MFN 07-425

Docket No. 52-010

Subject: **Response to Portion of NRC Request for Additional Information  
Letter No. 70 – Related to ESBWR Design Certification Application –  
RAI Number 14.2-44**

**RAI Number 14.2-44**

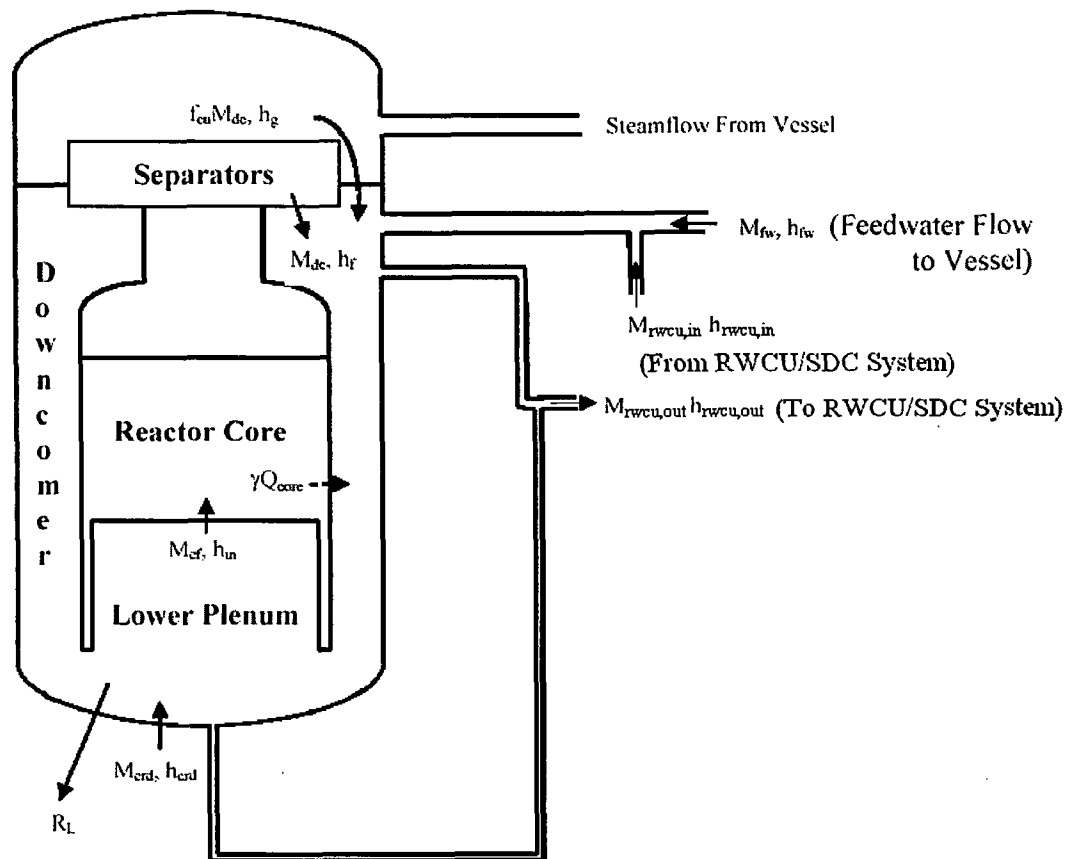
*Please provide specific methods on how you will calculate core flows and core power. What variables will be obtained from the in-vessel measurement to calculate core flows and core power? Please provide a detailed test plan for testing vessel natural circulation at various power levels after fuel loading during startup testing.*

Under normal operation condition, a control volume (CV) is established or defined as the liquid volume of the downcomer region and lower plenum region as shown in the following schematic figure. In the figure, key flow paths are identified to keep track of the mass and energy across the boundaries (entering or leaving) the CV. The basic idea of heat balance method is to use the steady-state conservation of mass and energy equations for the CV to derive an equation for the core flow.

The following equation can be obtained from mass conservation of CV

$$M_{cf} + M_{rwc, out} = M_{dc}(1 + f_{cu}) + M_{fw} + M_{rwc, in} + M_{crd} \quad (1)$$

Thus, equations (1) and (2) form a linear system in terms of unknowns  $M_{cf}$  and  $M_{dc}$ , where the remaining terms in equations (1) and (2) can be either measured or evaluated based on measurement. Therefore,  $M_{cf}$  can be solved by eliminating  $M_{dc}$  and the solution can be summarized in a single equation as a function of all the following terms
